# SERVICE BULLETIN

M-1032

## SAFETY RECALL CODE 082 STARTER RELAY

**Figure 1. Proper Positions of Original Starter Relay Wiring Harness Leads in Original Connector Block -- 1989 and 1990 Models (VIEWED FROM WIRING LEAD SIDE)**

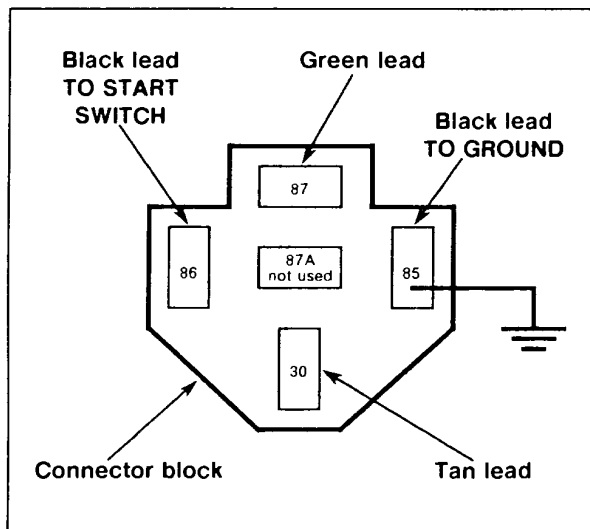
7. On 1989 and 1990 models only, see Figure 1. Use an ohmmeter or test light to verify that black "ground" wire lead of original relay wiring harness is properly located in the "85" position within harness's connector block. In some instances on these model years, the black ground wire was transposed with the black "start switch" wire in the "86" position of the connector block. If the black wires are reversed on your vehicle, carefully remove the black wire terminals from the connector block, and insert them in their proper positions within the connector block. Proceed to Step 8 after reading the following CAUTION statement.

Since the new starter relay in this kit incorporates a "one-way" diode in its circuitry, it is critical that position "85" of the original relay wiring harness connector be occupied by the black ground wire. Otherwise, the relay's diode will sustain damage when the starter circuit is activated.

**Figure 2. New Relay Wiring Harness Routing**

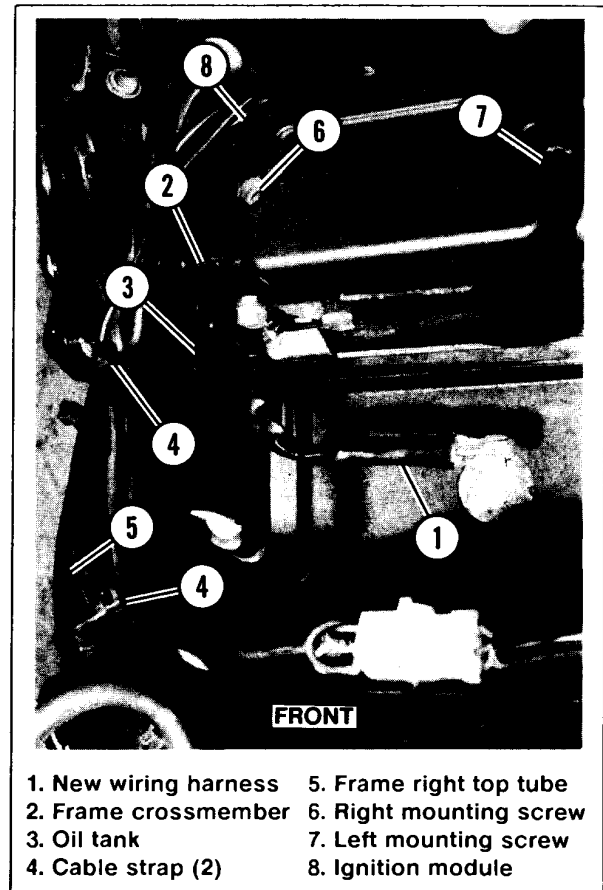
8. Connect new wiring harness from kit (end which has male spade terminals in connector block) to open connector of original harness; do not apply grease to terminals before connection.
9. See Figure 2. Route loose end of new harness (1) (end with female spade terminals) upward through opening between frame crossmember (2) and right rear upper corner of oil tank (3) as shown.
10. See Figure 3. Insert female spade terminals of new harness into appropriate positions of new connector block from kit.

11. Connect new starter relay from kit onto new harness connector block.
12. See Figure 2. Cut existing cable straps (4) which secure several wiring harnesses to frame right top tube (5).

21. On 1991 and 1992 models, see Figure 2. Remove ignition module right mounting screw (6). Loosen, but do not remove, ignition module left mounting screw (7). Pivot ignition module forward somewhat.
22. On all models, see Figure 5. Position parts from kit in the following order: starter relay mounting bracket (1), new starter relay (2), and starter relay cover (3). Secure components together by installing self-tapping screw (4) from kit through small mounting hole in cover (3), relay (2), and bracket (1).

**Figure 3. Positions of New Starter Relay Wiring Harness Leads in New Connector Block (VIEWED FROM WIRING LEAD SIDE)**

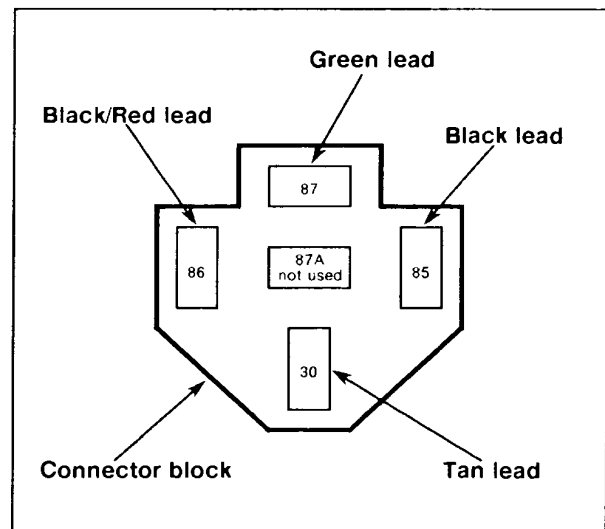
*Insert each spade terminal into connector block so that terminal locks in place within connector (i.e. -- terminal will not pull out when wiring lead is tugged). If terminal does not lock in place, it may be incorrectly oriented within connector; withdraw terminal from connector, rotate terminal 180°, and then reinstall terminal into connector.*

Figure 4. Original and Relocated Ignition Module Wiring -- 1989 and 1990 Models

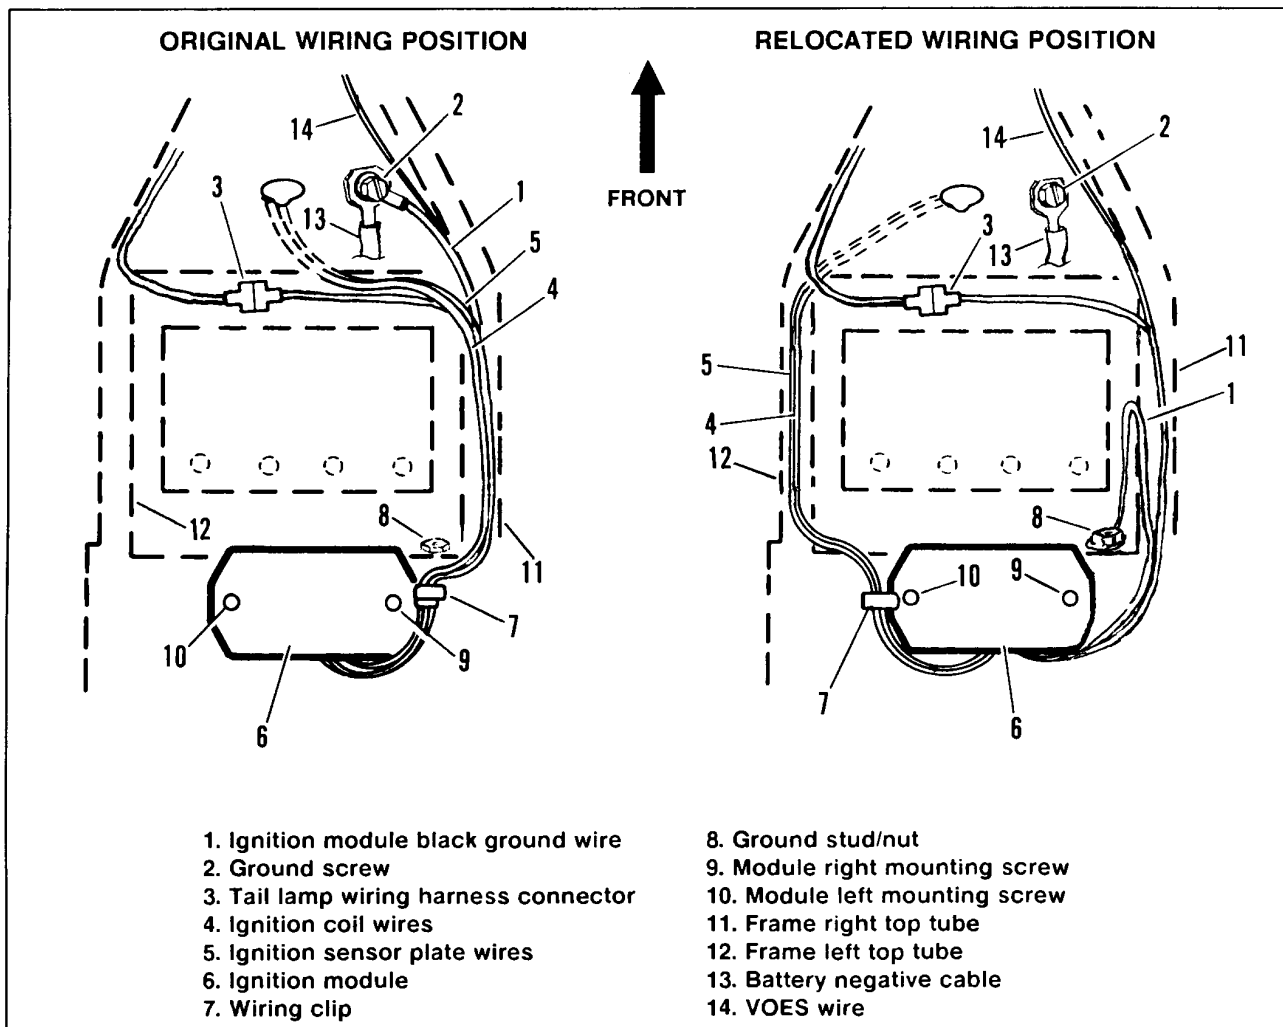
13. On 1989 and 1990 models, proceed to Step 14; on 1991 and 1992 models, proceed to Step 21.
14. On 1989 and 1990 models only, see Figure 4. Remove ground screw (2) which secures ignition module black ground wire (1) and battery negative cable (13) to motorcycle frame. Reinstall the ground screw, securing only the battery negative cable (13) to the frame; leave ground wire (1) loose.
15. Remove ignition module right mounting screw (9). Remove wiring clip (7) which was secured under ignition module (6) by right mounting screw. Save screw and clip for installation later.

16. Separate two halves of tail lamp wiring harness connector (3).
17. Relocate only the ignition coil wires (4) (two wires in conduit) and the ignition sensor plate wires (5) (three wires in conduit) from frame right top tube (11) to frame left top tube (12) as shown; leave the module black ground wire (1), VOES wire (14), and other wiring harnesses in place on frame right top tube (11).

18. Remove ignition module left mounting screw (10). Install wiring clip (7) (from Step 15) over relocated coil wires (4) and sensor plate wires (5). Position mounting hole of clip under left mounting hole of ignition module (6). Insert left mounting screw (10) through module and clip, and then loosely install screw into motorcycle frame. Pivot ignition module forward somewhat.

19. Reconnect two halves of tail lamp wiring harness connector (3) together over top of relocated coil wires (4) and sensor plate wires (5).
20. Relocate loose ignition module black ground wire (1) (from Step 14) to ground stud/nut (8) (stud/nut is part of right rear fork bumper and is currently used as a grounding point by existing starter relay black ground wire); tighten nut securely. Proceed to Step 22.

**Figure 5. New Starter Relay, Mounting Bracket, and Cover Assembly**

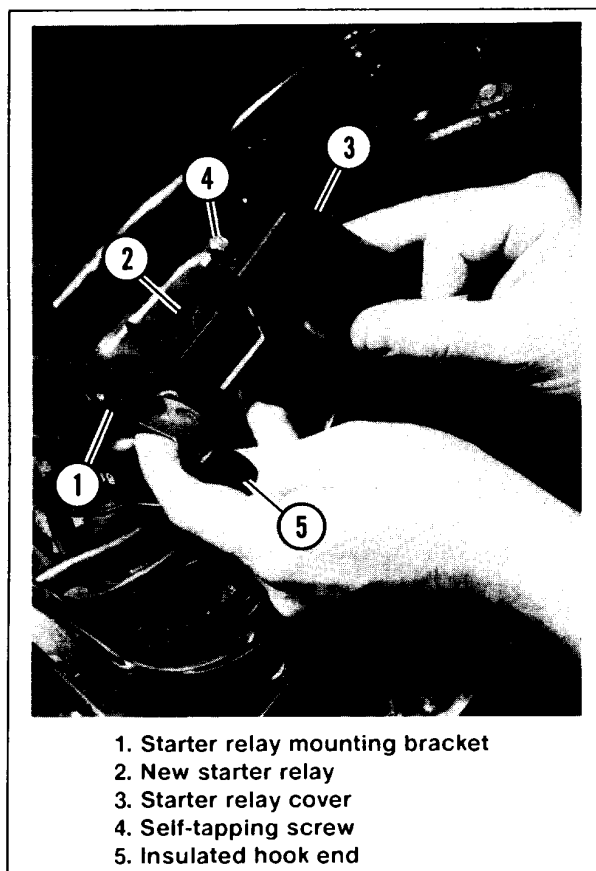
23. Pivot insulated "hook" end (5) of starter relay mounting bracket (1) away from relay cover (3) enough to allow insertion of loose wiring harnesses (resting along frame right top tube) into hook of bracket. Capture wires in hook by pivoting bracket back toward relay cover.

**Figure 6. New Starter Relay Assembly - Installed (1989/1990 Model Shown)**

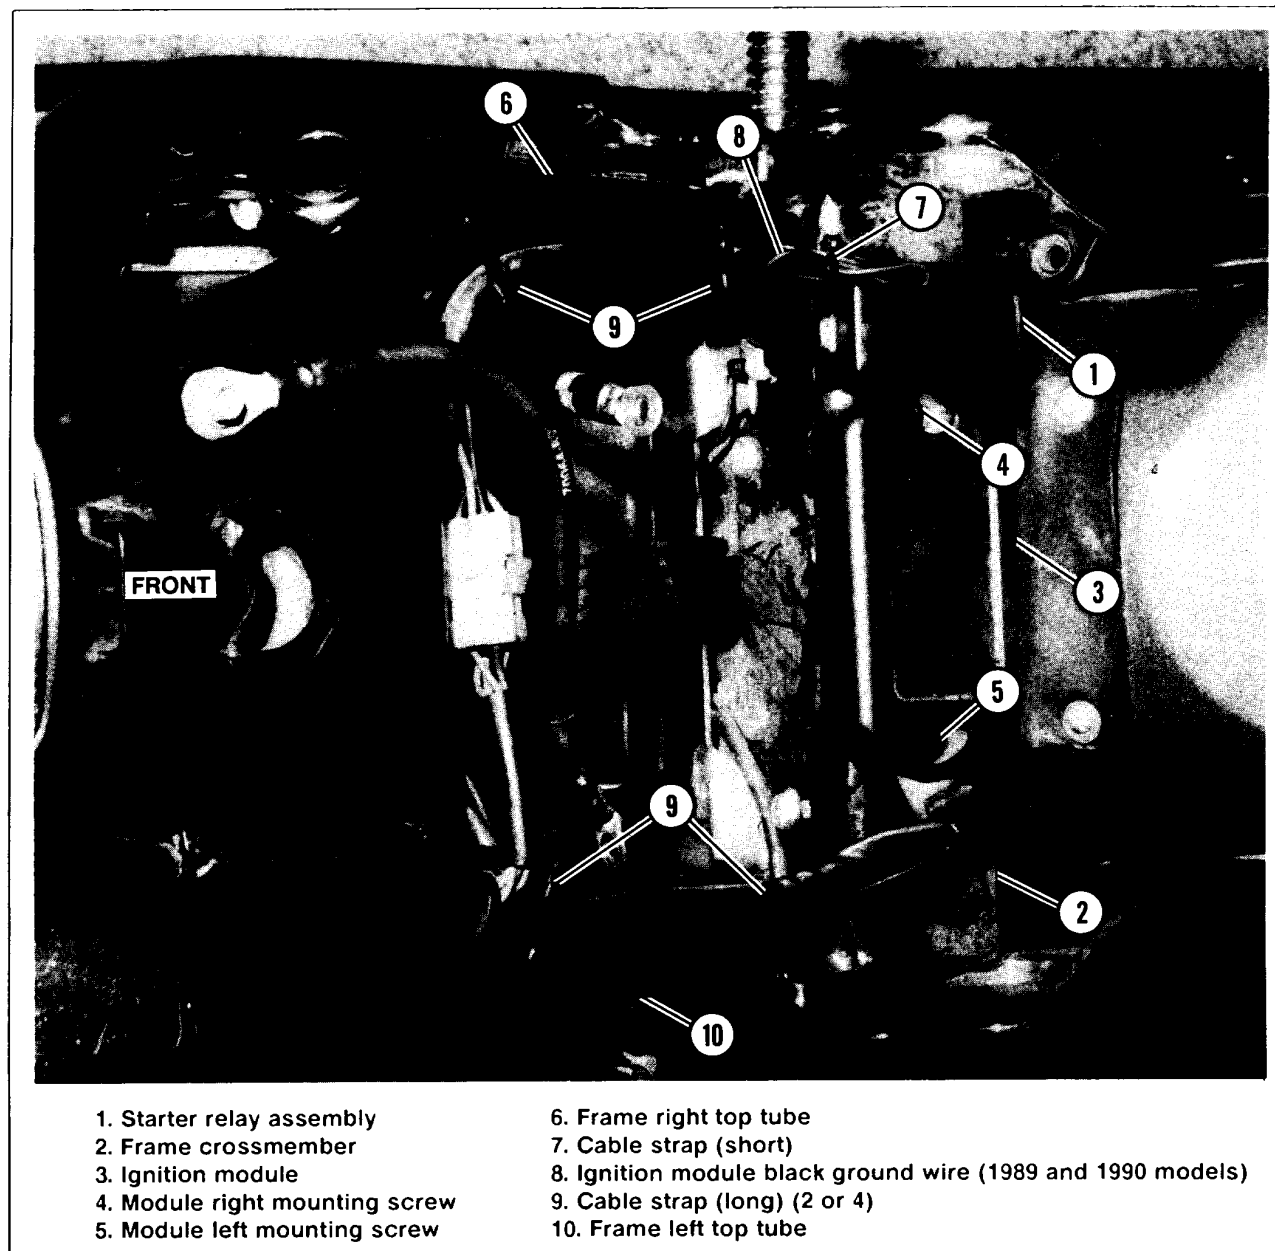
24. See Figure 6. Place starter relay assembly (1) (new starter relay, mounting bracket, and cover) onto frame crossmember (2) on right side of ignition module (3), aligning large mounting hole of relay mounting bracket with crossmember hole used to mount right side of ignition module. Pivot ignition module so that its right mounting hole aligns with the crossmember hole. Insert original right mounting screw (4) through hole in ignition module and relay mounting bracket, and loosely thread into crossmember hole.

- Verify that no wires along the frame right top tube are positioned beneath the starter relay mounting bracket. Otherwise, the wires could be pinched between the relay mounting bracket and the frame crossmember when the ignition module right mounting screw is tightened.
  - Verify that no wires along the frame right top tube are positioned above the starter relay cover. Otherwise, the wires could be pinched between the relay cover and the motorcycle seat when the seat is installed.
25. Press starter relay assembly (1) inboard, toward ignition module (3) as shown, and then tighten ignition module right mounting screw (4) securely. Tighten left mounting screw (5) securely.
  26. Secure together the loose wiring harnesses which are resting along the frame right top tube (6) using the kit's short cable strap (7) in the position shown.

*On 1989 and 1990 models with original ignition module (3) only, make sure any slack in ignition module black ground wire (8) is coiled together and properly secured by the short cable strap (7).*

27. Secure loose wiring harnesses to frame right top tube (6) using two of the kit's long cable straps (9) in the positions shown. On 1989 and 1990 models only, also secure loose wiring harnesses to frame left top tube (10) using two of the kit's long cable straps (9) in the positions shown.
28. On all models, install battery. Connect battery cables to battery, positive cable first.
